U S NAVY RESPONSE TO FLORIDA DEPARTMENT OF ENVIRONMENTAL PROTECTION  
COMMENTS TO MONITORING ONLY PLAN FOR CONTAMINATION ASSESSMENT  
REPORT ADDENDUM SITE 2662W NAS PENSACOLA FL  
10/27/1995  
ABB ENVIRONMENTAL SERVICES, INC

**SUBJECT:** Response to FDEP Comments dated September 21, 1995 and Submittal of the Monitoring Only Plan Recommendation for the Contamination Assessment Report Addendum for Site 2662W  
Naval Aviation Depot (NADEP)  
Naval Air Station, Pensacola, Florida.  
Contract No. N62467-89-D-0317, CTO No. 008.

**FIGURE 4-1  
PROPOSED MONITORING WELL  
LOCATION MAP**

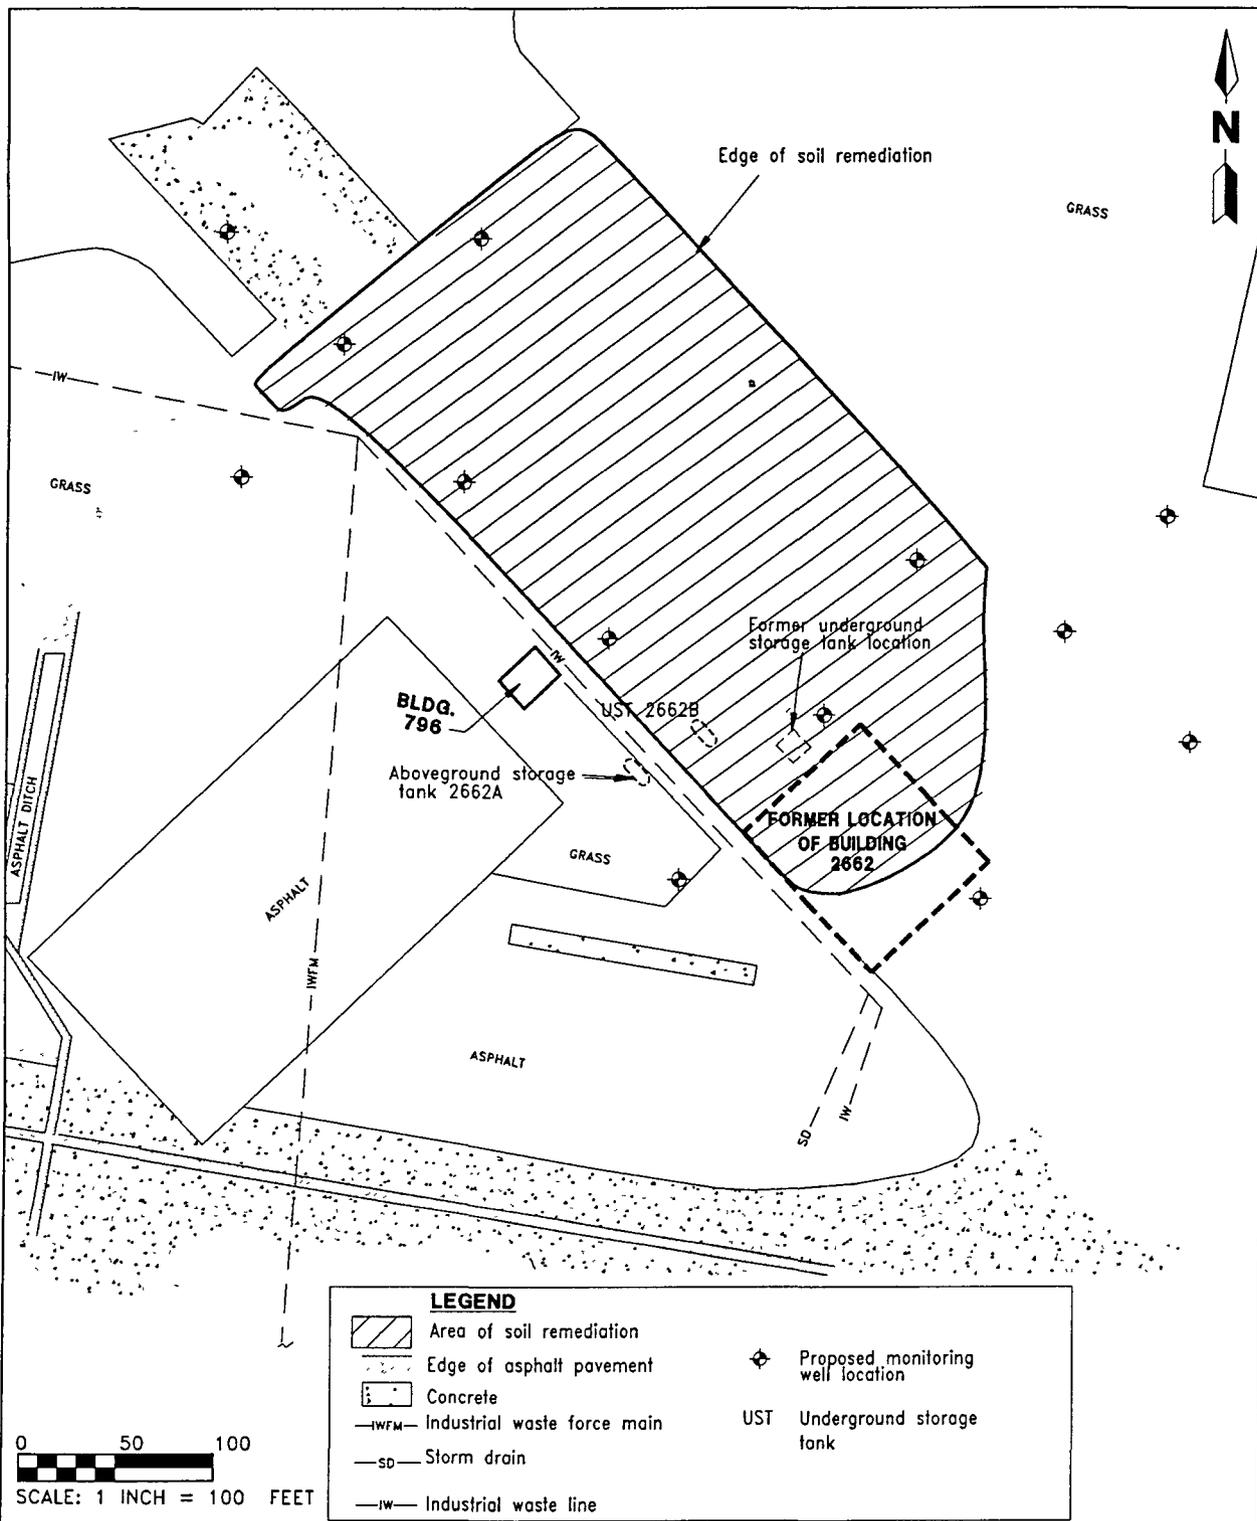
Several questions remain: 1) can the CAR Addendum be approved "as-is" with the MOP recommendation? 2) If we considered the area near temporary well TW-11 as an additional source area could the CAR for Site 2662W be approved? If so, the area surrounding well TW-11 would be assessed as a new site.

- The installation of thirteen monitoring wells in the vicinity of former permanent and temporary monitoring wells MW-2, MW-15, MW-51, TW-3, TW-4, TW-9, TW-10, TW-11, TW-12, TW-13, TW-16, TW-17, and TW-18 to replace those wells destroyed during site construction activities or abandoned (see Figure 4-1). The wells will be constructed of 2-inch inside diameter schedule 40 polyvinyl chloride (PVC) casing with flush-threaded joints and 10 feet of 0.010-inch machine-slotted screen.
